INITIAL FIRE SAFETY INSPECTION REPORT

Fullcharm Fashion Knitters Ltd

RSC ID: 25955

Date: 11-February -2025

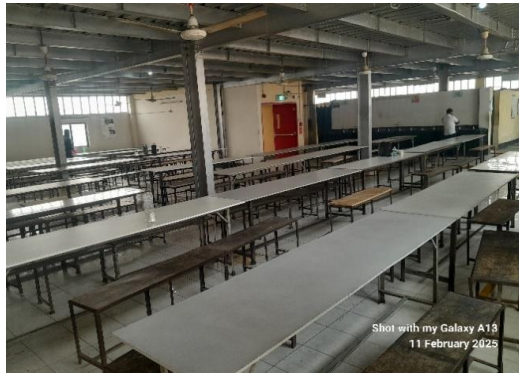
SI No.	Category	Findings	Required Action	Remediation Time Frame
F-01	Fire Rated Construction	Unprotected openings in the exterior wall in two consecutive floors lying not laterally within 1.5 m and vertical spread of fire is not restricted. Location: Building-1(production building-1) & building-2(production building-2)	Openings in the exterior wall in two consecutive floors lying within 1.5 m laterally shall be separated with a flame barrier projecting at least 75 CM from the external face of the exterior wall. The flame barrier shall have a fire resistance rating of not less than three-fourths hour as per BNBC 2006, part-3, section: 3.1.7.2	Within 3 months
<div style="display: flex; justify-content: space-around;">   </div>

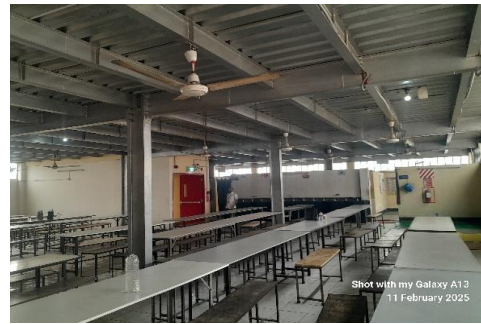
F-03	Fire Rated Construction	<p>The Dining area (E3) is not separated by fire rated construction with the adjacent store occupancy.</p> <p>Location: 6th Floor of building-1</p>	<p>Separate the dining area from production & other occupancies (present temporary storage) by minimum 3-hr fire rated construction. Provide rated exit passageways leading directly to the exit stairs of the same resistance rating.</p>	Within 3 months
------	-------------------------	---	--	-----------------

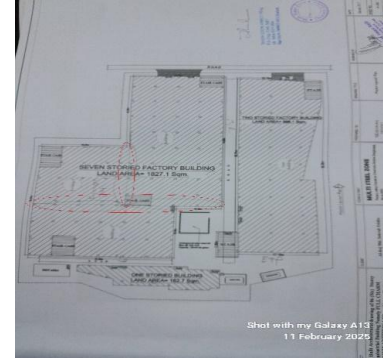
F-05	Fire Rated Construction	<p>Unsealed penetrations and openings are located in the fire-rated floor/ceiling assemblies.</p> <p>Location: Construction expansion joint & steam pipe for building-1 (production building-1)</p>	<p>Seal all penetrations and openings in floor/ceiling assemblies to maintain the fire separation at least by 3-hr. The used sealer shall be 3rd party certified and installation shall be as per manufacturer's datasheet.</p> <p>Or</p> <p>Provide a minimum 2-hr fire rated shaft to separate the utility risers from each floor if required.</p>	Within 3 months

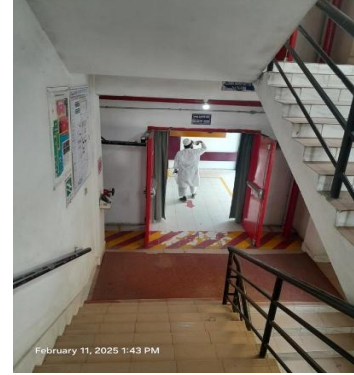
F-9	Means of Egress	Width of exit stairs are less than 1.5 m (60 in.) Location: Building -1, Stair-1 = 57inch, Stair-2 = 58inch, Stair-4 = 44 inch.	In new and interim construction and constructed stairs post 24 November 2013, stairs shall have a minimum width of 1.5 m (60 in.) for all industrial occupancies and 2.0 m(79 in.) for all assembly occupancies. For assembly use areas provided for prayer halls, dining halls and like areas that are for integral use by the factory workers, the minimum width for the primary occupancy use of the building shall be permitted to be used.	Within 3 months
-----	-----------------	--	---	-----------------

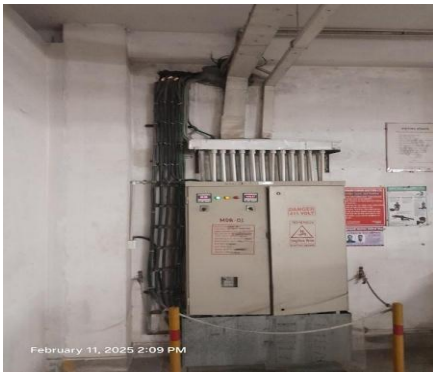
F-16	Fire rated construction	<p>Fire pump room is not separated due to unprotected openings and penetrations due to cable tray.</p> <p>Location: Ground floor of Building-1</p>	<p>Provide fire pump room with 2 hr. rated fire separation by fire rated construction. Seal all unprotected opening & penetrations..</p> <p>Or,</p> <p>Physically separate the pump room from the protected building by a minimum of 50 ft. (15.3 m) in accordance with NFPA 20.</p>	Within 1 month
------	-------------------------	--	--	----------------

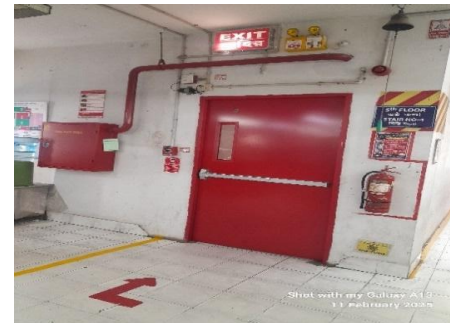
F-26	Fire Protection System(Standpipe)	Standpipe system installation requires detailed review to confirm compliance with NFPA- 14 , 20 ,22 & 24 or as per RSC standard.	<p>Submit the standpipe system drawing to RSC for review. Once the design is reviewed, install and modify the standpipe system throughout the building in accordance with review comment, RSC Standard and NFPA- 14,20,22 and 24.</p> <p>After installation the owner shall conduct internal testing and commissioning and then contact the RSC for witness of final acceptance testing.</p>	Design Review within 1 month and modification within 3 months (If require).
------	-----------------------------------	--	--	---
